Re: Turkey Point Units 3 and 4 Docket Nos. 50-250 and 50-251

Response to NRC Request for Additional Information Regarding Extended Power Uprate License Amendment Request No. 205 and Reactor Materials Issues

# RESPONSE TO NRC RAI REGARDING EPU LAR NO. 205 AND CVIB REACTOR MATERIALS ISSUES

Figure 2: Modified P-T Limits TS Bases (For Information Only)

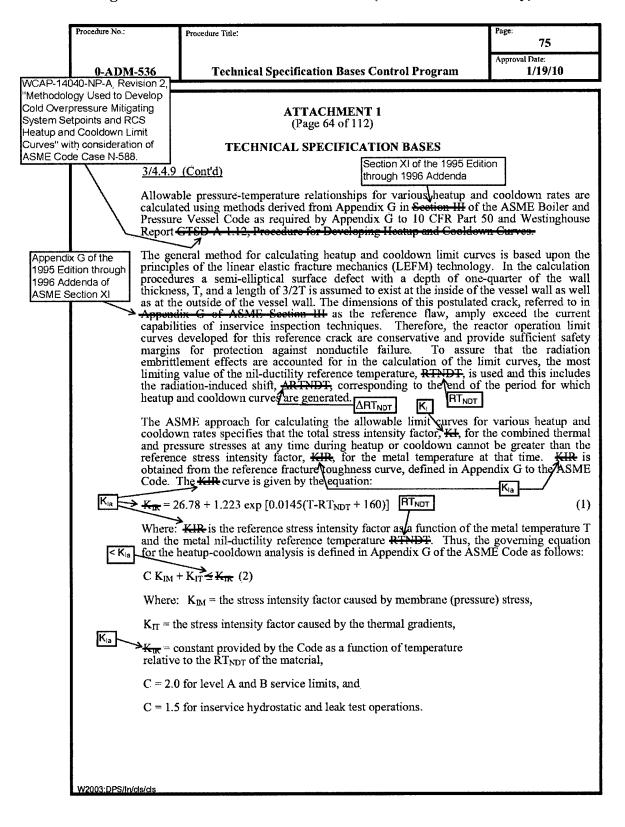
CVIB-2.1 In the licensee's RAI response letter dated March 9, 2011, Figure 1, the Modified Technical Specification (TS) Bases 3/4.4.9, states that WCAP-14040-NP-A, Rev. 2, "Methodology Used to Develop Cold Overpressure Mitigating System Setpoints and RCS Heatup and Cooldown Curves" is one of the methodologies used to evaluate the fracture toughness properties and to determine the allowable pressure-temperature relationships. However, in the response to CVIB-1.4-b, the methodology of WCAP-14040-NP-A, Rev. 4 is referenced with respect to the determination of the coolant-to-crack tip temperature differential. In addition, during the conference call on January 26, 2011, the licensee identified that the methodology used to generate the P-T limits was the same as that described in WCAP-15092, Rev. 3, which incorporates the provisions of Code Case N-588. WCAP-14040-NP-A, Rev. 2 does not incorporate the Code Case N-588 provisions, but WCAP-14040-NP-A, Rev. 4, incorporates the provisions of Code Case N-588.

1. Clarify which revision of WCAP-14040-NP-A is used as the basis for the P-T limit calculations for Turkey Point Units 3 and 4, (Rev. 2, Rev. 4, or a combination of both) and correct the TS bases as necessary.

The P-T limit calculations for Turkey Point Units 3 and 4 were performed using WCAP-14040-NP-A, Revision 2. The provisions of ASME Code Case N-588 have not been incorporated into this revision of the WCAP; however, the Code Case was utilized in the development of the P-T limit curves (See response to item 2 below). See Figures 1 and 2 for TS Bases changes.
